Engineering Change Request		ECR Number	10415W	
Initiator:	Wayne	Date:	2026.06.22	
Part number description				
Item	K3 Code material part numbers	Drawing/ Doc Number	Version of current related document	New Version
1	See attached list of changed part numbers	/	/	/
2	/	/	/	/
Reason of change:				
<input type="checkbox"/> Customer requirement (list the feasibility analysis of customer specification: _____) <input type="checkbox"/> Supplier request (list the PCR number: _____) <input type="checkbox"/> internal improvement <input type="checkbox"/> corrective <input checked="" type="checkbox"/> other				
<u>Please describe here in detail:</u>				
To improve the salt spray resistance of the locking screws on the back cover of the Gen3 CCS2 socket, the salt spray requirement has been upgraded from 96H to 240H. This change is solely for enhancing the product's salt spray resistance rating and has no impact on its original functionality..

To improve the salt spray resistance of the locking screws on the back cover of the Gen3 CCS2 socket, the salt spray requirement has been upgraded from 96H to 240H. **This change is solely for enhancing the product's salt spray resistance rating and has no

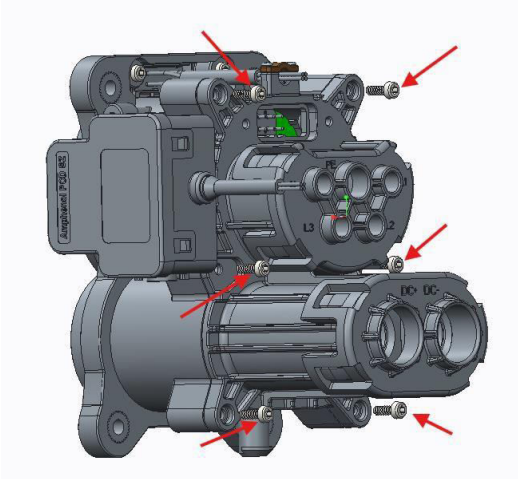
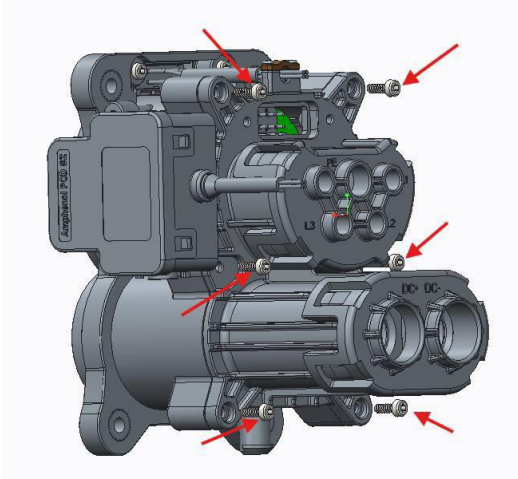
Before change	After change	
<p>1. Salt spray requirement: 72H; Specification: ST2.9×10; Color: Silver</p> <p>2. Part number: C210006302</p>  	<p>1. Salt spray requirement: 240H; Specification: ST2.9×12; Color: Grey</p> <p>2. Part number: P01BM00214</p>  	
<p>Disposition of old materials</p> <p> <input type="checkbox"/> Rework <input checked="" type="checkbox"/> Use as it is <input type="checkbox"/> scrap <input type="checkbox"/> Other (please describe) : _____ <input type="checkbox"/> N/A </p>		<p>Expect date to switch to new material</p> <p style="text-align: center;"><u>2026.07.15</u></p>
<p>Approval by the supervisor of requester.:</p> <p style="text-align: center;"><i>Jank</i></p>	<p>Approval by the head manager of the request dept.:</p> <p style="text-align: center;"><i>ding</i></p>	
<p>Customer approval :</p> <p> <input type="checkbox"/> Approved <input type="checkbox"/> No approved <input type="checkbox"/> Conditional approval (please describe) : _____ </p> <p>Signature : _____ Date : _____</p>
